UNITED STATES PATENT AND TRADEMARK OFFICE

APPLICATION NO.	FILING DATE	FIRST NAMED INVENTOR	ATTORNEY DOCKET NO.	CONFIRMATION NO.
09/977,543	10/15/2001	Matthew M. Persohn	65857-0033 (01-AQP-275-VA)	1294
10291	7590	07/20/2004	EXAMINER	
RADER, FISHMAN & GRAUER PLLC 39533 WOODWARD AVENUE SUITE 140 BLOOMFIELD HILLS, MI 48304-0610			DUNWOODY, AARON M	
			ART UNIT	PAPER NUMBER
			3679

Office Action Summary

DETAILED ACTION

FIG. 12

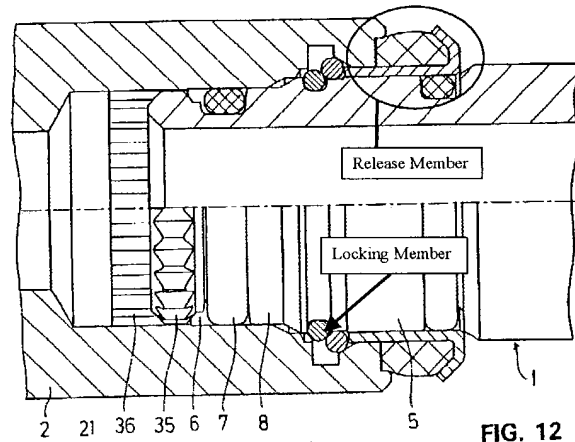
In regards to claim 32, in Figure 12 below, Funk discloses a coupling assembly comprising:

- a first member (1) including a retaining formation having at least one engagement feature (35);

- a second member (2) having a portion for receiving a portion of the first member, the receiving portion having at least one interior surface that includes at least one locking feature (36) configured to mate with the engagement feature of the first member to inhibit rotation of the first member relative to the second member during connection thereto; and

- a locking member received in the second member. Funk does not disclose the locking member being positioned between the retaining formation and the second member when the first and second members are connected. Bizilia teaches a locking member (14) being positioned between the retaining formation

(7) and the second member (4) when the first (1) and second members are connected. As Funk and Bizilia solve the problem of coupling a first member to a second member, it would have been obvious to one having ordinary skill in the art at the time the invention was made to position the locking member between the retaining formation and the second member when the first and second members are connected, since it has been held that rearranging parts of an invention involves only routine skill in the art. *In re Japikse*, 86 USPQ 70.
